Subject: D15 External PSU Cable Clamp

Figure 1. Installation detail

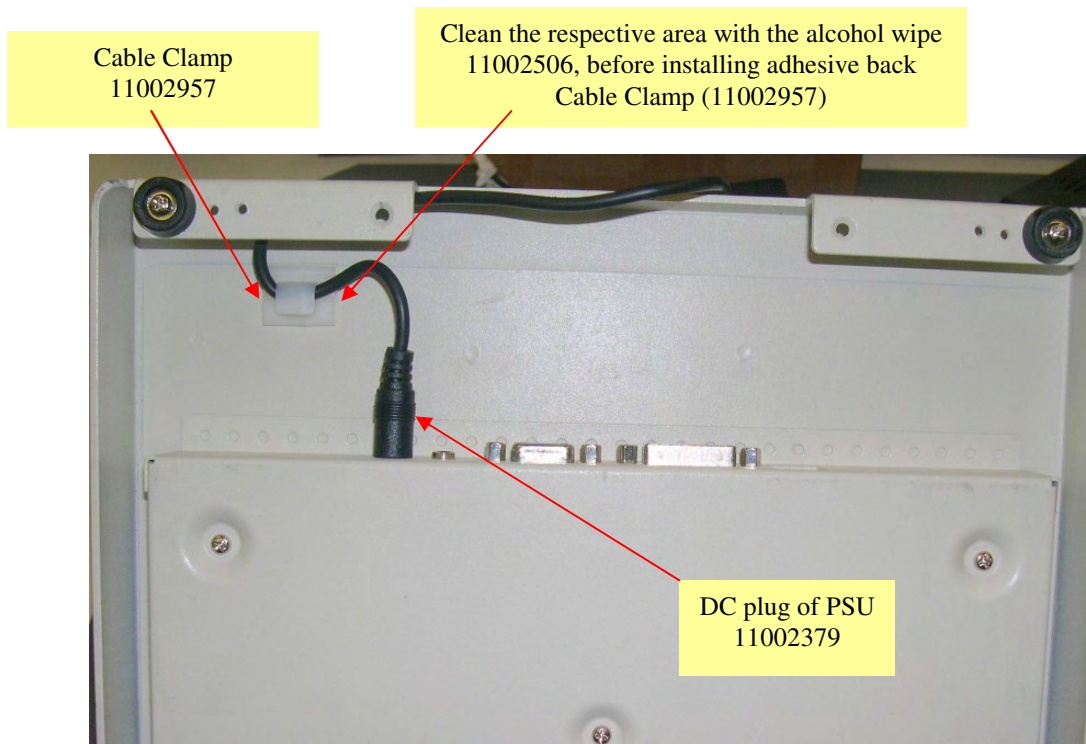
The Barrel type connector the new External D15 PSU (11002379) has been found to not fit tightly and is easily pulled loose. Reference PSB-08-001 for details of this new PSU.

An adhesive cable clamp is available for the D15 display stand to prevent the cable from coming loose. For logistics and field repairs, order a cable clamp (11002957) along with the new External PSU (11002379) whenever the old power supply fails.
